## ***Interactive comment on “Water-soluble iron correlation to primary speciated organics in low-emitting vehicle exhaust” by Joseph R. Salazar et al.***

**Joseph R. Salazar et al.**

Received and published: 13 December 2019

Fig. 1.

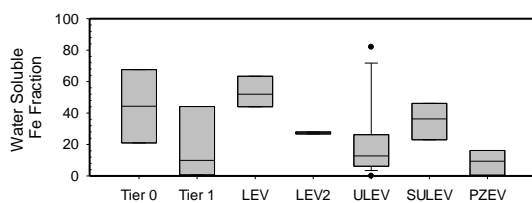
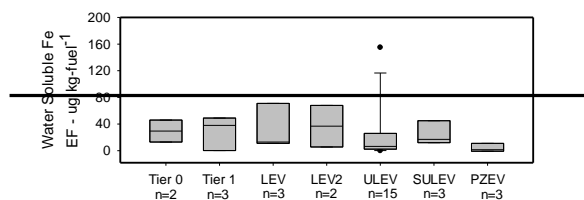
Figures 1 and 2: I’m wondering if it could be more informative to present the total iron emissions as, e.g., Figure 1a, and then have Figure 1b include box plots of the water-soluble iron fraction. This is just a thought that could potentially be more informative to drive home how much of the iron is actually water-soluble.

Reply: This is a great suggestion and we thank the reviewer. Below is the revised graph and the removed graph.

Figure 2: Water-soluble iron from the 32 vehicles tested reported in water-soluble iron fraction. The center black line represents the median value and the edges of the boxes represent the 25<sup>th</sup> and 75<sup>th</sup> percentiles while the whiskers are the 10<sup>th</sup> and 90<sup>th</sup> percentiles.

Figure 2: Water-soluble iron from the 32-vehicles tested reported in EF (µg kg<sup>-1</sup> fuel<sup>-1</sup>). The center black line represents the median value and the edges of the boxes represent the 25<sup>th</sup> and 75<sup>th</sup> percentiles while the whiskers are the 10<sup>th</sup> and 90<sup>th</sup> percentiles.
